Preliminary Consultation
MONTGOMERY COUNTY HISTORIC PRESERVATION COMMISSION
STAFF REPORT

Address:	10201 Menlo Ave.	Meeting Date:	9/19/18
Resource:	Vacant lot Capitol View Park Historic District	Report Date:	9/12/18
Review:	Preliminary Consultation	Public Notice:	9/5/18
Applicant:	Minter Farnsworth	Staff:	Dan Bruechert
Proposal:	New Construction

The applicant proposes to construct a single-family home on the property located at 10201 Menlo Ave. and seeks feedback from the HPC prior to the submission of a HAWP application.

Figure 3: The subject lot with the identified easements.

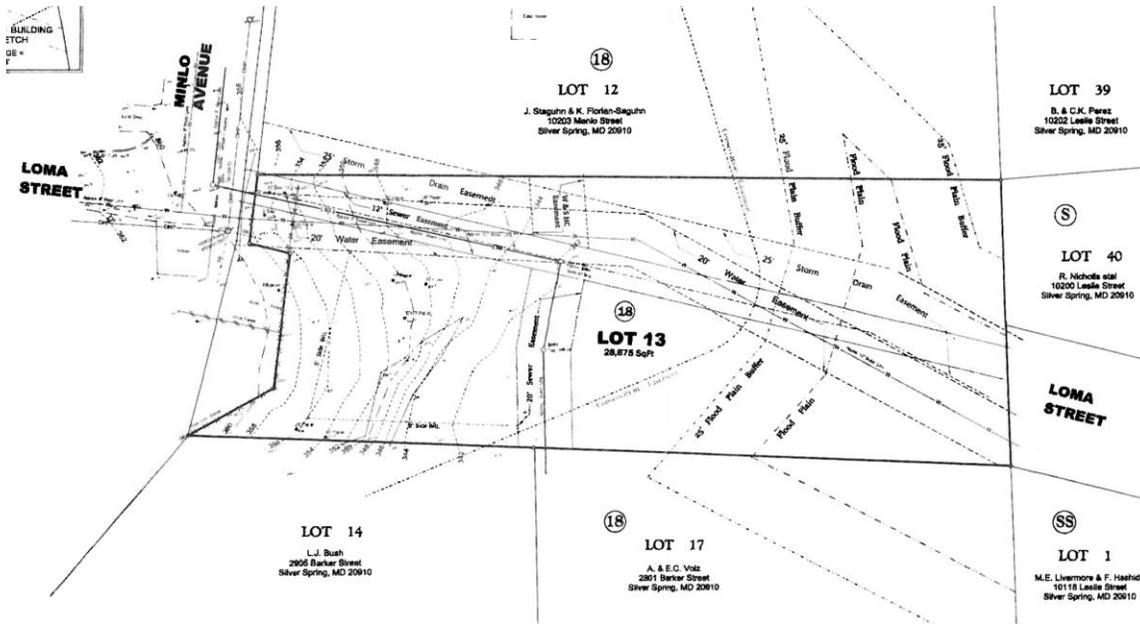
The subject property is located at the intersection of Loma St. and Menlo Ave. The lot has several challenges that somewhat limit what can be built on the site. First, the lot offers narrow access at the corner of Loma and Menlo. Much of the lot sits to the south of Loma St., so that only 15’ (fifteen feet) of the property abuts the public right-of-way. There are no other locations where a driveway onto the site could go. Second there are several utility easements that run

across the site. There is a 25' (twenty-five foot) storm water easement, a 20' (twenty foot) water easement, and a 12' (twelve foot) sewer easement that runs both north to south and another that runs east to west. The applicant is permitted to pave on top of these areas, but may not build on them. Finally, there is a conservation easement in the rear of the lot, encompassing 12,478 ft² (twelve thousand, four hundred and seventy-eight square feet), which is approximately forty-three percent of the total lot. Nothing may be constructed or altered within this easement. These limitations, coupled with zoning setback requirements, create a buildable envelope of 5,160 ft² (five thousand, one hundred sixty square feet) in the southwestern corner of the lot.

Figure 4: Streetscape study along Menlo Ave.

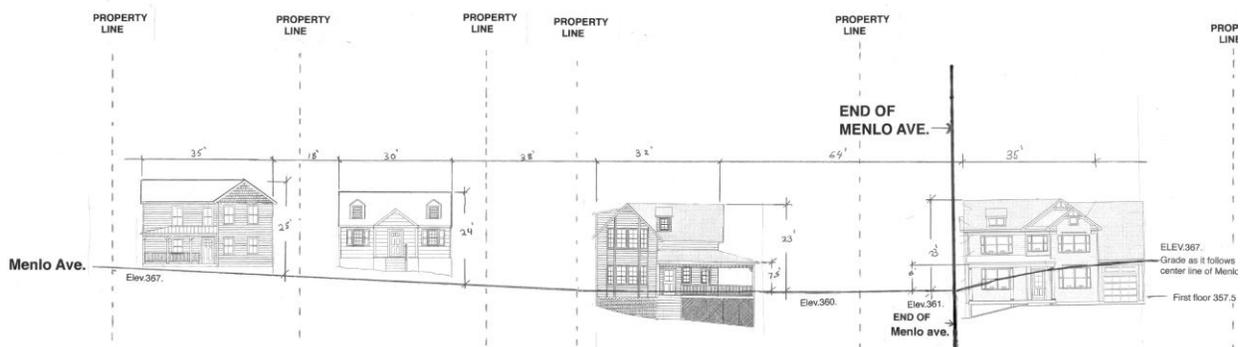
The proposed construction will be 23' (twenty-three feet) above the grade of Menlo Ave. Staff finds that the height is generally consistent with the surrounding district (see the streetscape study below).

Figure 5: Setback study along Menlo Ave.

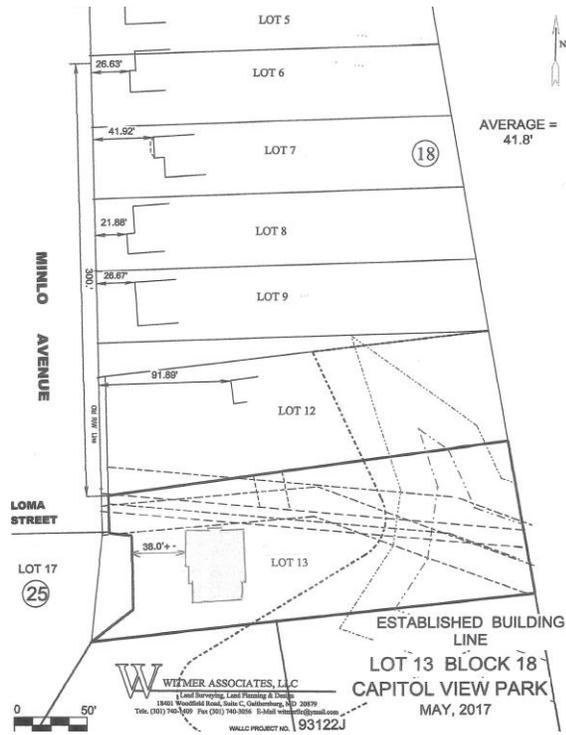
The applicant included a setback study (shown below). The setbacks on this section of the historic district range from approximately 22' (twenty-two feet) to nearly 92' (ninety-two feet). While the setback of the proposed construction is slightly deeper than many of the late 19th century and 1920s houses further up the block, it is generally consistent with the existing streetscape.
